EXPEDITED SETTLEMENT AGREEMENT

Number: ES-081223-2

Response to Inspection: STORMWATER INSPECTION REPORT for CERT. NO. COR-03 9947 on 5/9/07 Inspector: Brenner Perrymen (PG Environmental, LLC)

Facility: Echo Canyon Estates 1185 18 Road Fruita, CO in Mesa County

Ribertore Enterprises Corrective Measures Photographs (Echo Camyon)

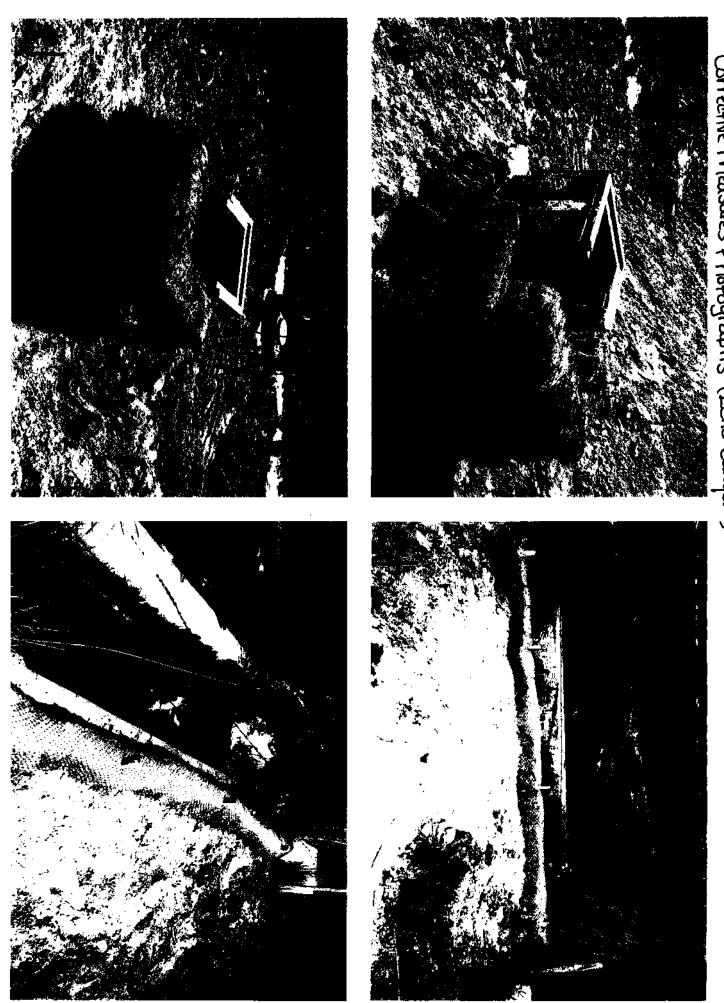
In Response to Observation #2 -

In Response to Observation #3 -

In Response to Observation #4 -

In Response to Observation #5 -

In Response to Observation #6 -

(Inspection Photograph 1) This item was immediately remedied by applying a Haystack BMP to prevent the discharge of sediment beyond the sediment pond. Please refer to Corrective Measures Photographs 1 and 2.

(Inspection Photographs 2 and 3) This item was immediately remedied by applying a Wattle BMP to prevent discharge of sediment offsite to the irrigation inlet. Please refer to Corrective Measures Photographs 3 and 4.

(Inspection Photograph 4) This item was immediately remedied by applying a new Wattle BMP completely around the storm sewer drain and clearing any sediment or debris from the top of the drain's grate and maintaining the item daily. Please refer to Corrective Measures Photograph 5.

(Inspection Photograph 5) This item was immediately remedied by securing the portable toilet with a on all sides of the portable toilet to prevent chemical, sanitary waste or pollutant spills from the toilet.

Please refer to Corrective Measures Photograph 6.

(Inspection Photograph 6) This item was immediately remedied by applying more rock to the track pad refer to Corrective Measure Photograph 7.

As of June 26, 2007 the track pad was completely eliminated and was permanently established with a paved asphalt road into the subdivision off 18 Road. (See Photograph 8)
